ADDENDUM NO. ONE (1)

CITY OF BILLINGS

AVIATION PLACE ROAD REHABILITATION

MMI # 2447.150.012

2
T-1
COMMUNICATIONS - HANDHOLE DETAIL
NOT TO SCALE

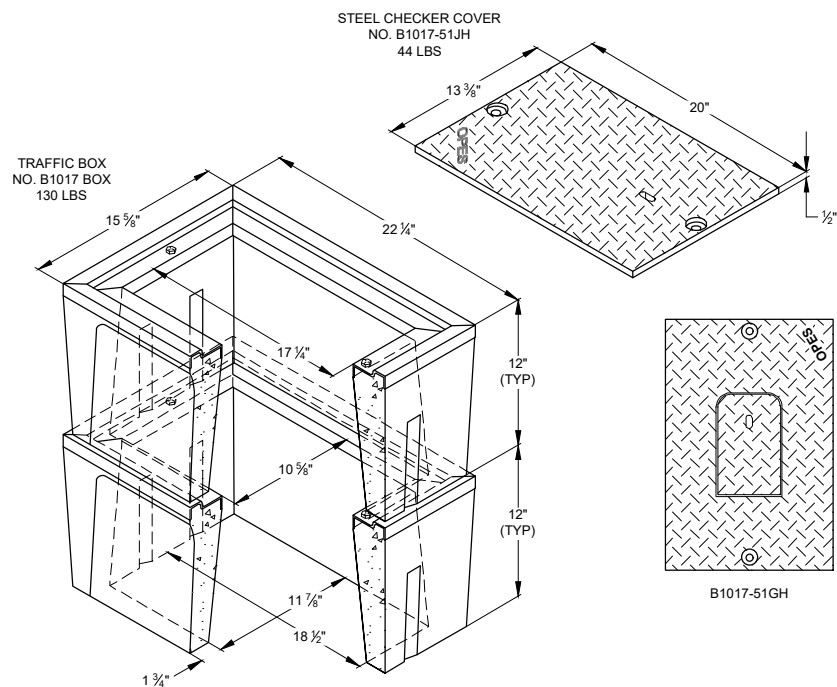
- Drawing T-2, Communication Details. Detail 2, Handholes need to be 24" deep.
- Drawing T-2, Communication Details. Detail 3, **ADDED** an Existing Vertical Pivot Gate detail used at the Airport. Each gate is field fit for existing conditions. **ADDED** new Detail 4, Handhole to Existing Pull Box Connection. There is a pull box outside the security fence and inside the security fence. The Airport and Engineer will field locate the best connection for the new fiber with the Contractor at each gate. If the best connection is inside the gate and the security fence is open through or under the fence, it shall not be left unattended while there is greater than a 3-inch gap. Any openings must be filled and/or closed by the end of the workday.
